## **Product Change Notice (PCN)**

PCN Number: PCN-0451089R-01

Product(s) Affected: PJ-041-SMT-TR

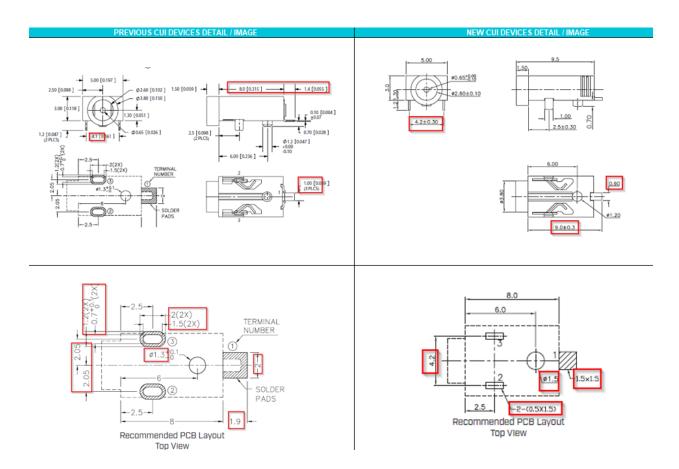
Description of Change: Minor Housing and footprint differences. Material Change on the housing and terminals. PCB pad sizes, spacings differ. New part will fit on previous footprint. See image Below

PF	REVIOUS CUI DEVICES DET	NEW CUI DEVICES DETAIL / IMAGE			
	MATERIAL PLATING	_	DESCRIPTION	N MATERIAL	PLATING/COLOR
center pin	copper nickel	_	center pin	bronze	silver
terminal 1	brass silver	_	terminal 1	bronze	silver
terminal 2	copper alloy silver		terminal 2	SUS301 t=0.20	gold
terminal 3	copper alloy silver	_	terminal 3	SUS301 t=0.20	gold
plastic	PAST or equivalent	_	housing	PA10T (UL94V-0)	black
